Informal document GRSP-54-02
(54th GRSP, 17-20 December 2013, agenda item 20)

Draft Regulation on hydrogen and fuel cell vehicles

The content of this document is identical to the English version of ECE/TRANS/WP.29/GRSP/2013/22, but the changes from GTR are indicated in coloured font or with strike-out by line.

Uniform provisions concerning the approval of motor vehicles and their components with regard to the safety-related performance of hydrogen-fuelled vehicles

Figure 2
Verification test for performance durability (hydraulic)

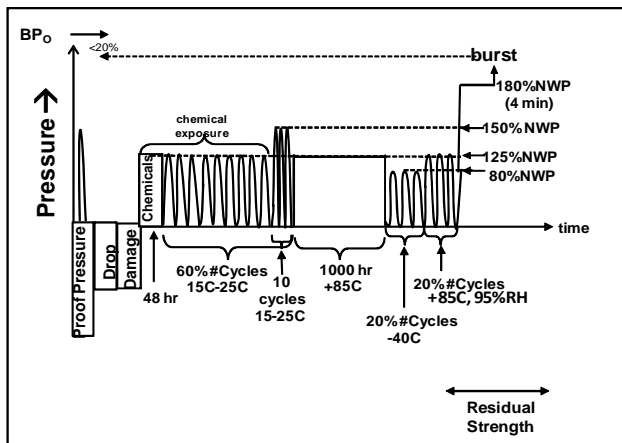
A hydrogen storage container shall not leak during the following sequence of tests, which are applied in series to a single system and which are illustrated in Figure 2. ~~At least one system randomly selected from the design qualification batch shall be tested to demonstrate the performance capability.~~ Specifics of applicable test procedures for the hydrogen storage system are provided in Annex 3, paragraph 3.

Figure 3.
Verification test for expected on-road performance (pneumatic/hydraulic)

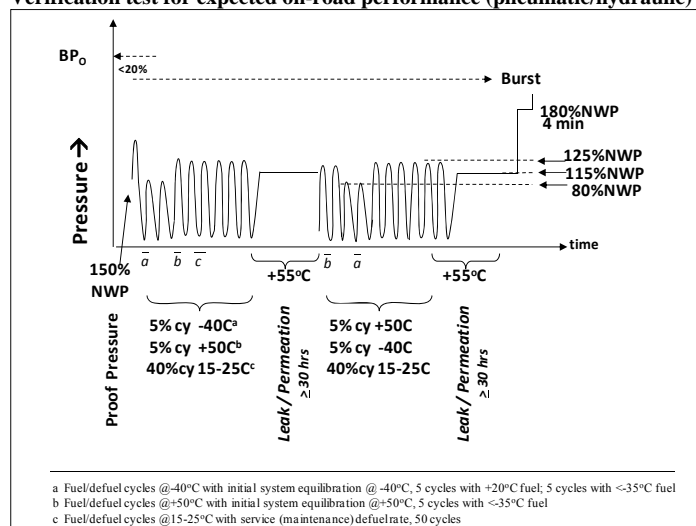
- 5.3. Verification test for expected on-road performance (Pneumatic sequential tests)
A hydrogen storage system shall not leak during the following sequence of tests, which are illustrated in Figure 3. Specifics of applicable test procedures for the hydrogen storage system are provided in Annex 3.

Figure 1
Drop orientations

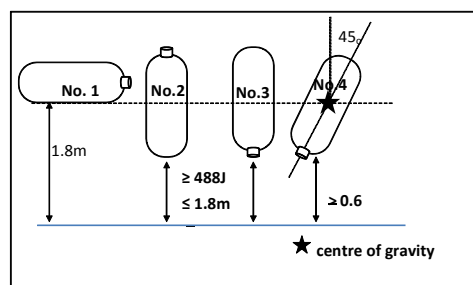
No attempt shall be made to prevent the bouncing of containers, but the containers may be prevented from falling over during the vertical drop tests described ~~in b)~~ above.
